# Technical Service BULLETIN

## M.I.L. "ON" DTC P0031, P0051, P2238, AND/OR P2241

### '04 Sienna

ENGINE  
EG001-05

**Calibration Identification Chart**

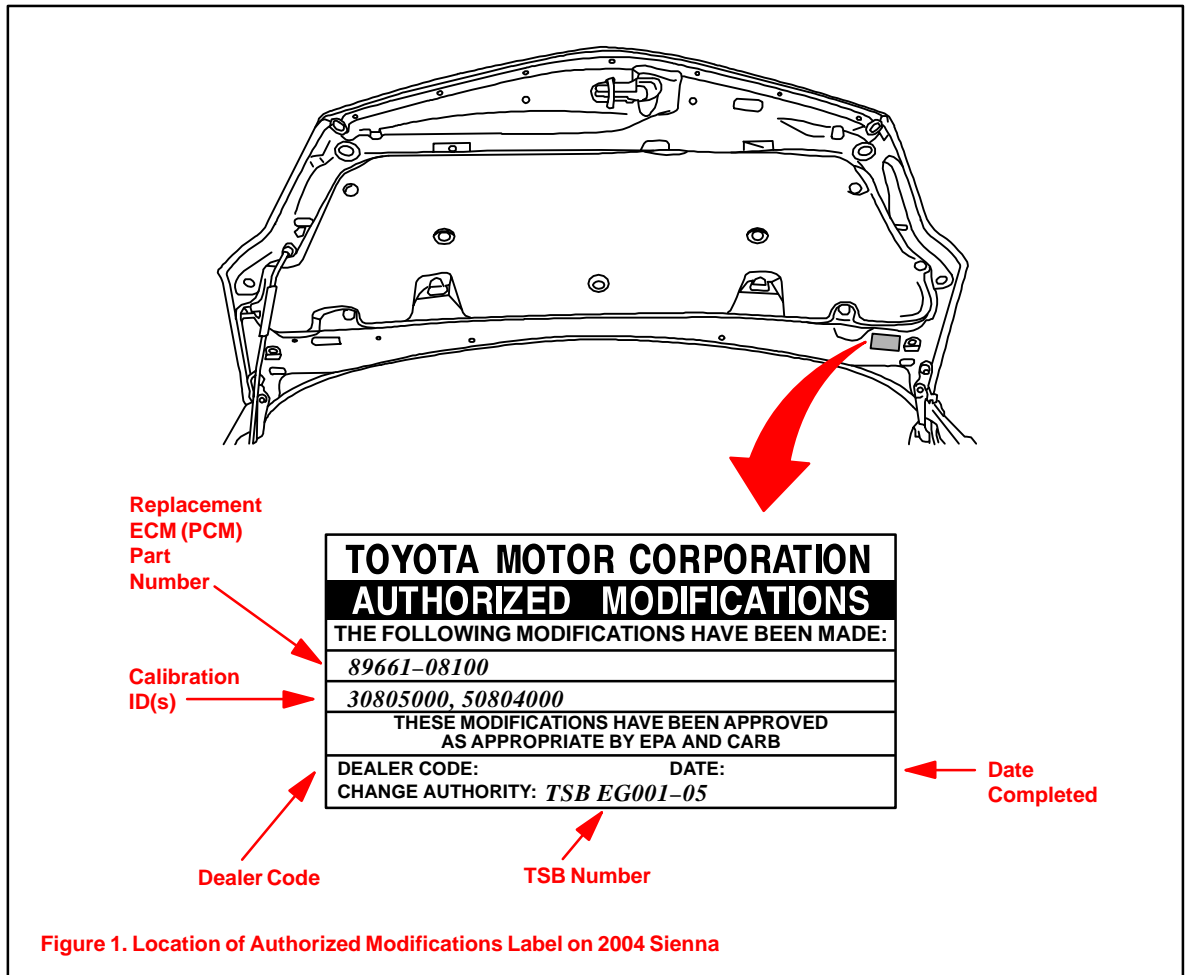
The A/F sensor manufacturing process and the Engine Control Module (ECM) (SAE term: Powertrain Control Module/PCM) logic have been modified to improve these conditions.

DRIVETRAIN	ECM (CPU)	PREVIOUS CALIBRATION ID	NEW CALIBRATION ID	
2WD	Main	30801000	30804000	
		30801100		
		30801200		
		30801300		
4WD	Main	50801000	50803000	
		50801100		
		30802000		30805000
		30802100		
30802200				
30802300				
4WD	Sub	50802000	50804000	
		50802100
